Access Compliance Report Public Rights-of-Way (Curb Ramps)

Main Street: CHARLOMA DR **Cross Street: LURLINE LN** NW Location:

Ramp Type: Type 1 - Perpendicular Diagonal Initial Pass/Fail: Pass ADA ID: RPAT211011100455

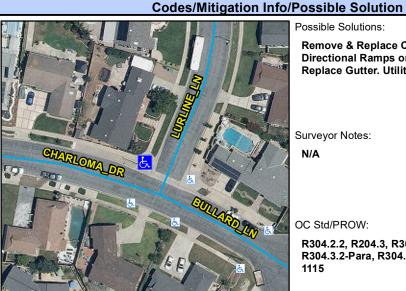
Overall Compliance: No Severity Score:

R304.2.2, R204.3, R304.2.1, R304.2.2-Perp, R304.3.2-Para, R304.5.3, R305, R304.5.4, STD 1115

Field Measurements/Component Compliance								
-	Com	pliance Description	Data	Com	pliance Description	Data		
	N/A	Ramp Length (in)	132	N/A	Flare Type LT			
	Yes	Ramp Width (in)	52			Sloped		
	Yes	Ramp Run Slope (%)	6.3	N/A	Flare Slope LT (%)	8.1		
	Yes	Ramp Cross Slope (%)	1.8	N/A	Flare Traversable LT	No		
	N/A	Landing Present	No	N/A	Flare Type RT			
	N/A	Landing Length (in)	N/A			Sloped		
	No	Landing Width (in)	N/A	N/A	Flare Slope RT (%)	6.9		
	No	Landing Run Slope (%)	N/A	N/A	Flare Traversable RT	No		
	No	Landing Cross Slope (%)	N/A	No	DWS Provided	No		
	N/A	Landing Movement Obstructed?	Yes	N/A	DWS Contrast	N/A		
		Landing Movement Type	Wall	N/A	DWS Length (in)	N/A		
	N/A	Landing Shared	N/A	N/A	DWS Full Width	N/A		
	N/A	Clear Space	Yes	N/A	DWS Offset Left (in)	N/A		
	N/A	Clear Space To Crosswalk (in)	48	N/A	DWS Offset Right (in)	N/A		
2	N/A	Marked Crosswalk 1	No	N/A	Marked Crosswalk 2	No		
		Crossing 1 Direction	E		Crossing 2 Direction	S

١ ا		Marked Crosswalk 1 Width (in)	N/A		Marked Crosswalk 2 Width (in)	N/A		
ı	N/A	Ramp Inside Crosswalk 1	N/A	Yes	Ramp Inside Crosswalk 2	N/A		
ı		Crossing 1 Slope (%)	6		Crossing 2 Slope (%)	2.7		
ı		Crossing 1 Cross Slope (%)	2.9		Crossing 2 Cross Slope (%)	4.1		
	Yes	Gutter Ponding	No	No	Curb Slope	8.2		
	Yes	Gutter Lip Height (in)	0		Road Run Slope (%)	0.4		
	No	Gutter Run Slope (%)	6.1		Road Cross Slope (%)	4.7

Remove & Replace Curb Ramp With Two New Directional Ramps or Equivalent. Remove & Replace Gutter. Utility Present.
